Development Review (Minor) Staff Approval

94-SA-2019

DC Ranch Market Street
Building Q Suite 110

Request: Rework existing southeastern windows and storefront for new windows and storefront with doors with material and finishes to match existing architecture.

A1.4

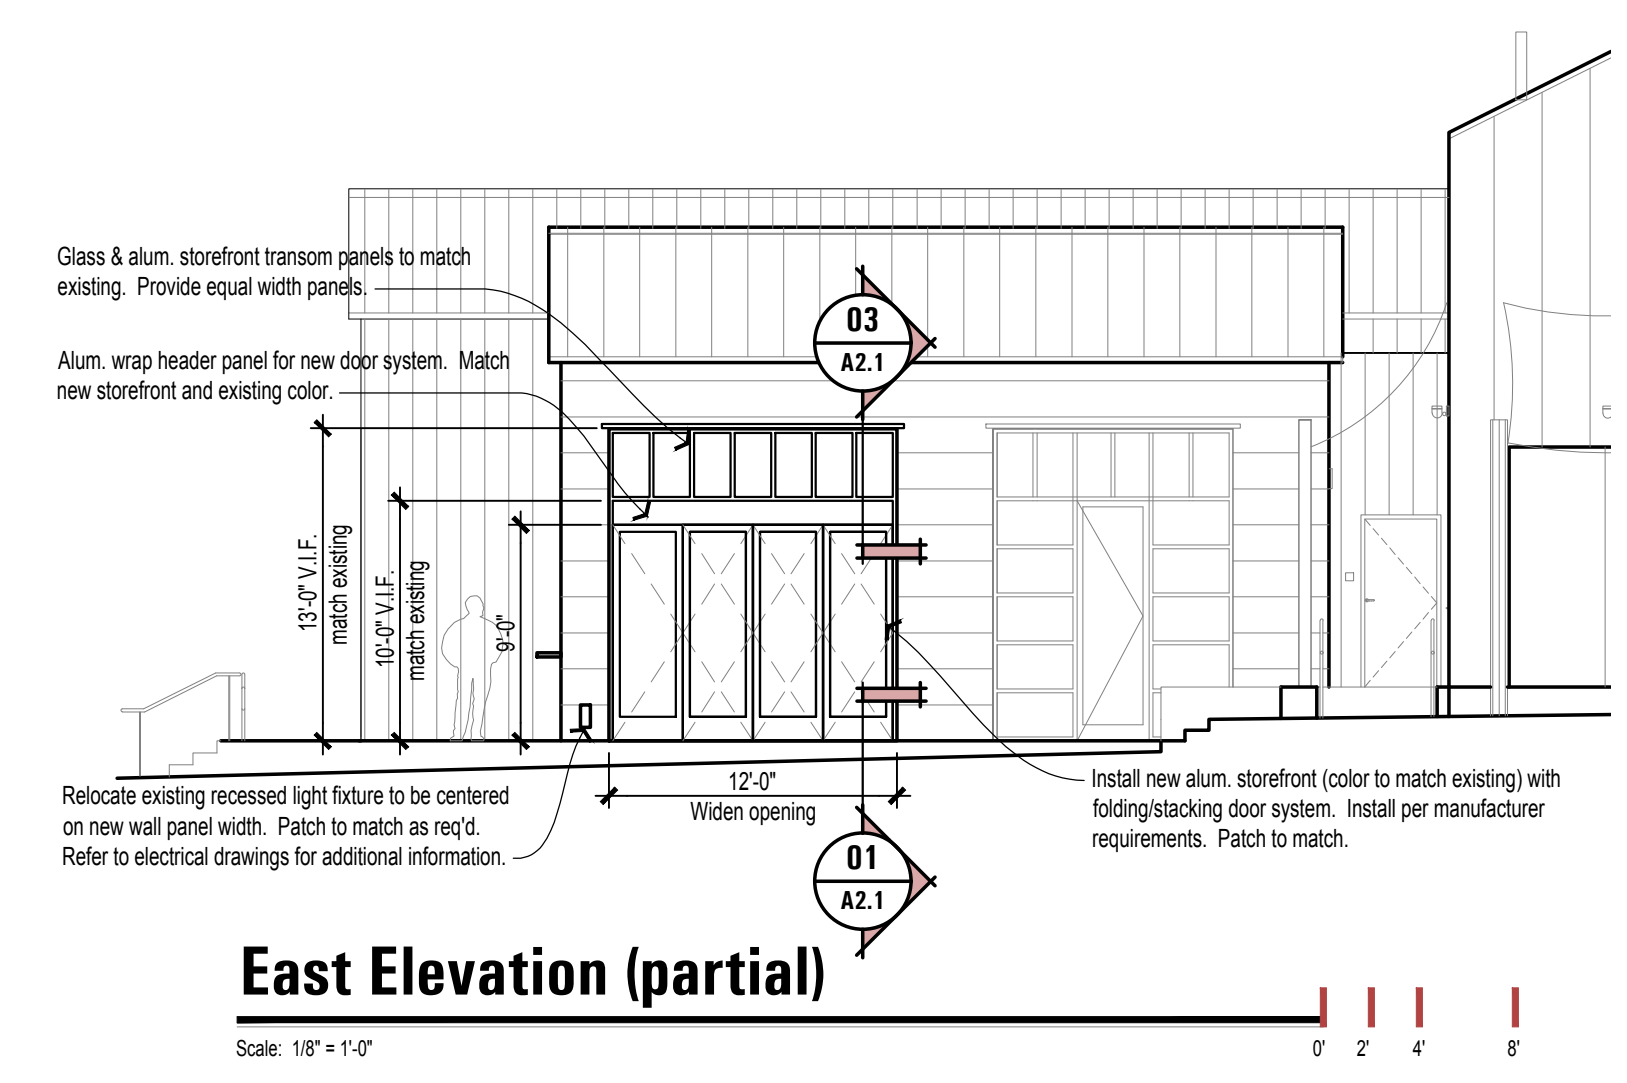
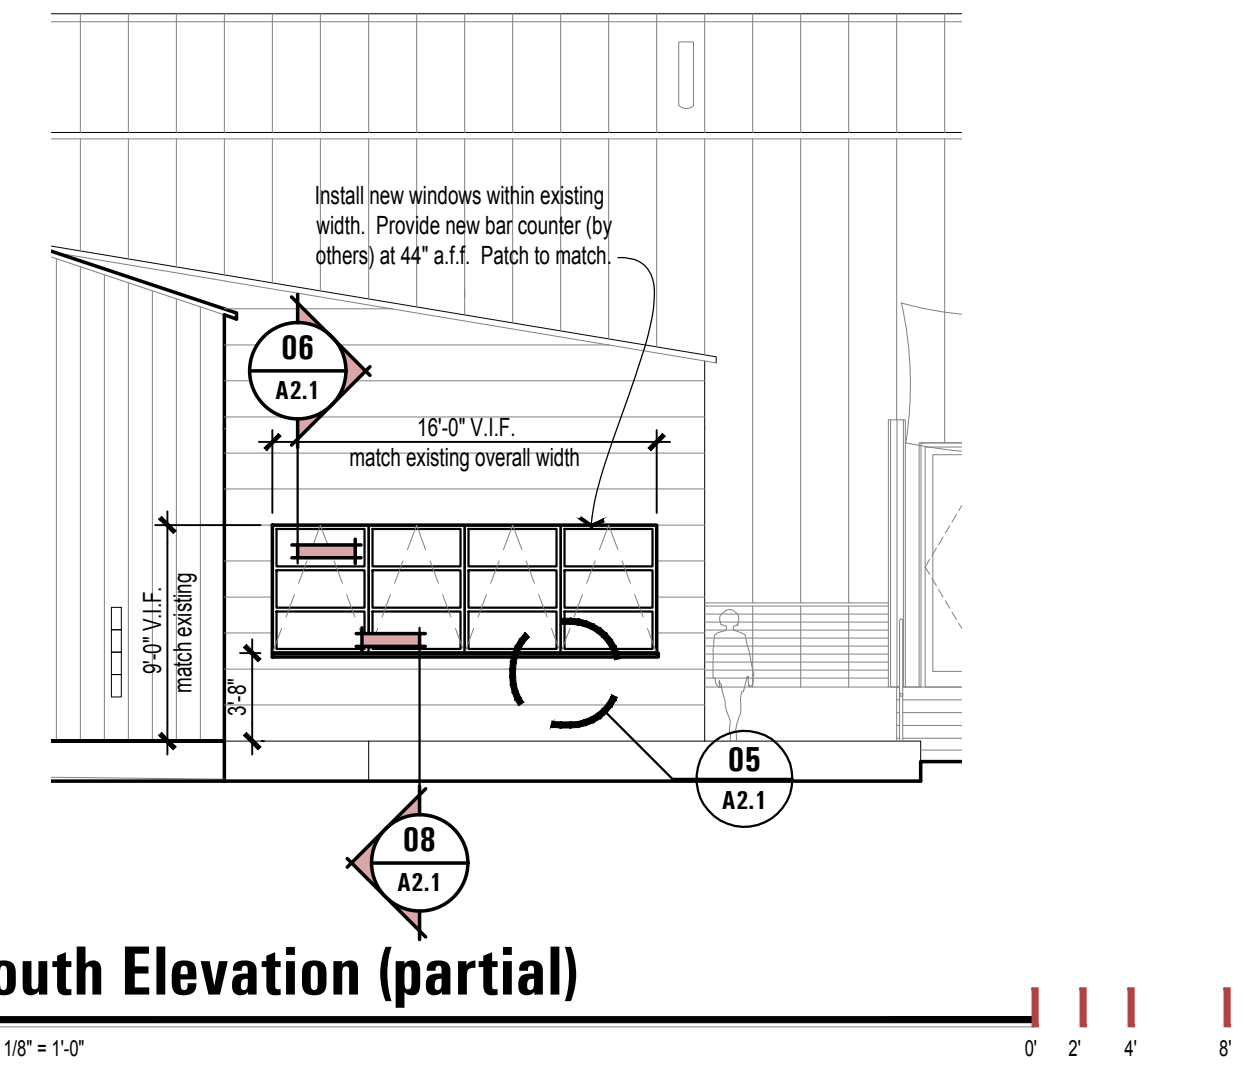
1. Architectural elements, including dimensions, materials, form, color, and texture, shall be constructed to be consistent with the building elevations submitted by LAVA Architecture, Inc., with a city staff date of 04/09/2019.
2. Exterior lighting and signs require a separate review and approval.
